RAI 03.07.02-29, Revision 1**QUESTION:**

RAI from Section 3.7 Audit, October 2010

REVISED RESPONSE:

Figure 03.07.02-29.6: Acceleration Response Spectrum for Thick Shell Element Model for Out-of-Plane Loading – Node 31 – 6 in. Wall

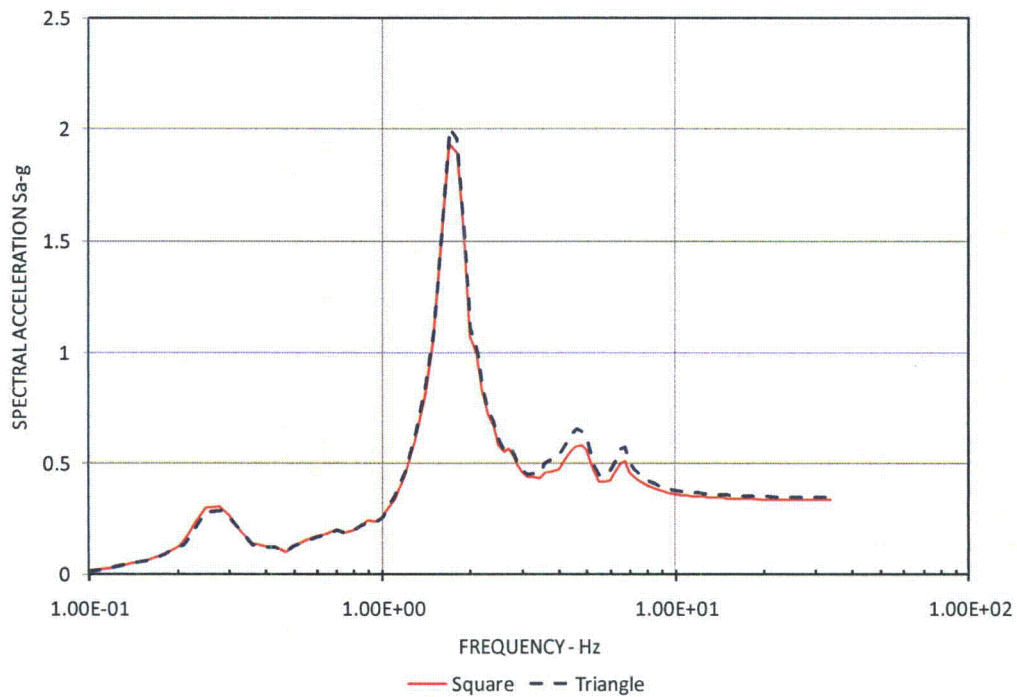
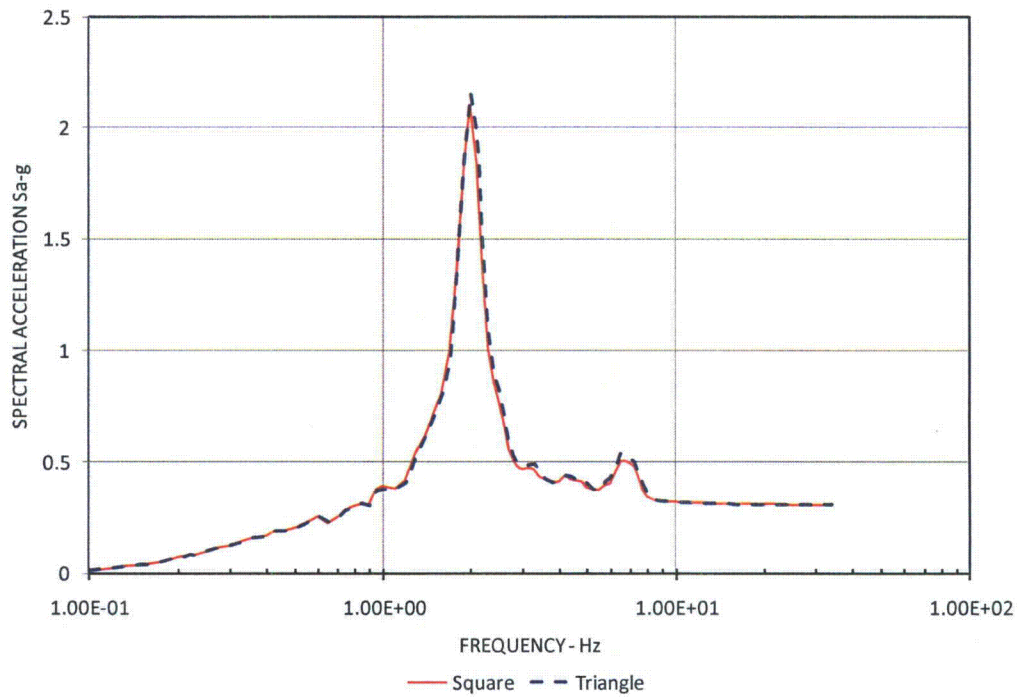
Significant differences in the out-of-plane acceleration response of thick versus thin shell element models have also been observed in the analysis results with the thick shell model producing lower responses. This also needs to be further evaluated for SASSI2000-v3.0 as to the adequacy and limitations of the specific shell element type.

Table 03.07.02-29.3 shows the natural frequency comparison and Table 03.07.02-29.4 shows comparison for peak response spectra. Figures 03.07.02-29.6 through 03.07.02-29.9 show comparisons of response spectra using the rectangular element model and the triangular element model. As can be seen from these comparisons, there is good agreement between the results from the triangular element model and the rectangular element model.

Figure 03.07.02-29.17: Comparison of 5% damped X-Direction Response Spectra at the Top of the Wall for Various aspect Ratios of Thin Plate Elements

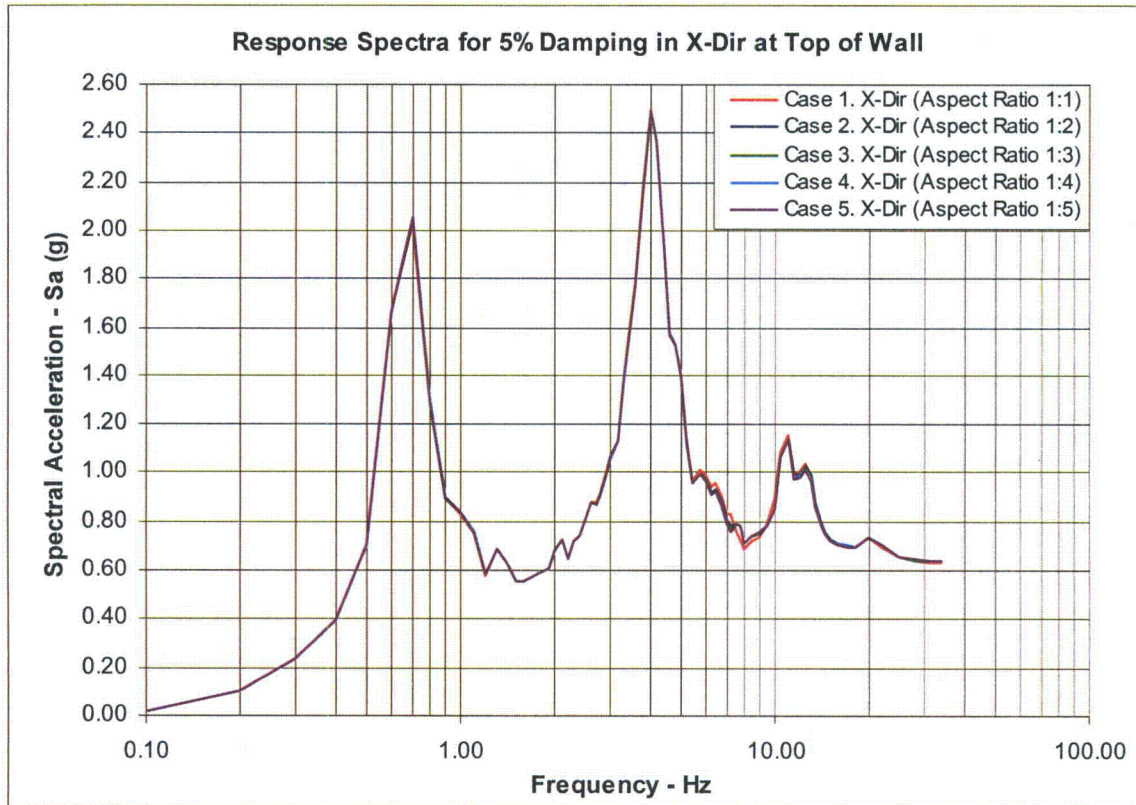
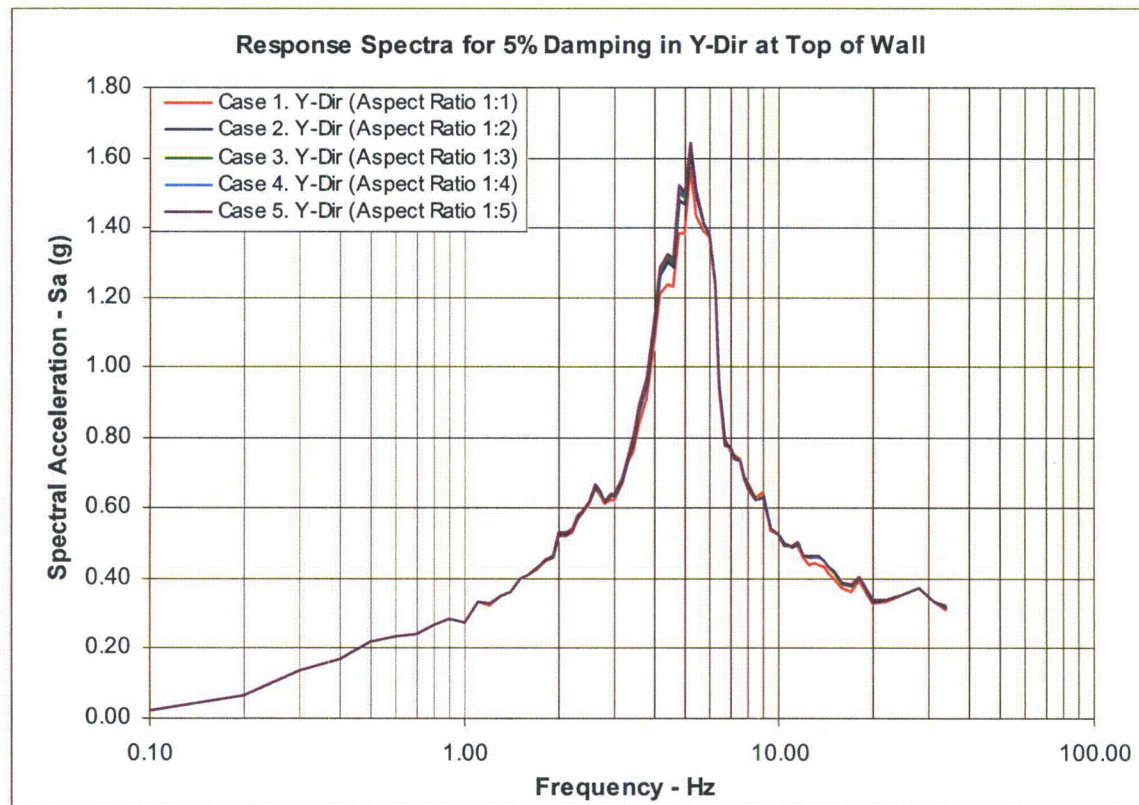
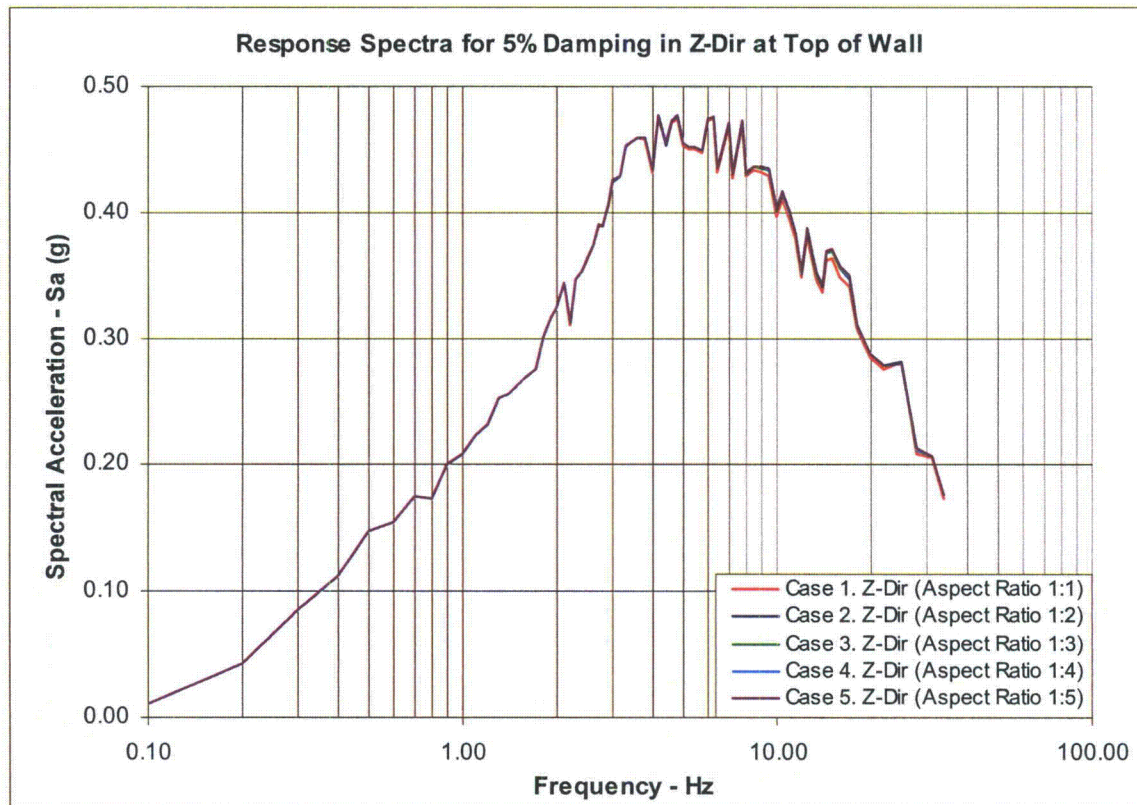
- **Acceptable aspect ratio of rectangular elements (solid, shell and plane-strain) to obtain accurate results, as used in the models**

Figures 03.07.02-29.17 through 03.07.02-29.19 show some typical comparisons of 5% damped in-structure response spectra. The comparisons show that the in-structure response spectra compare well for aspect ratios up to 1:5.
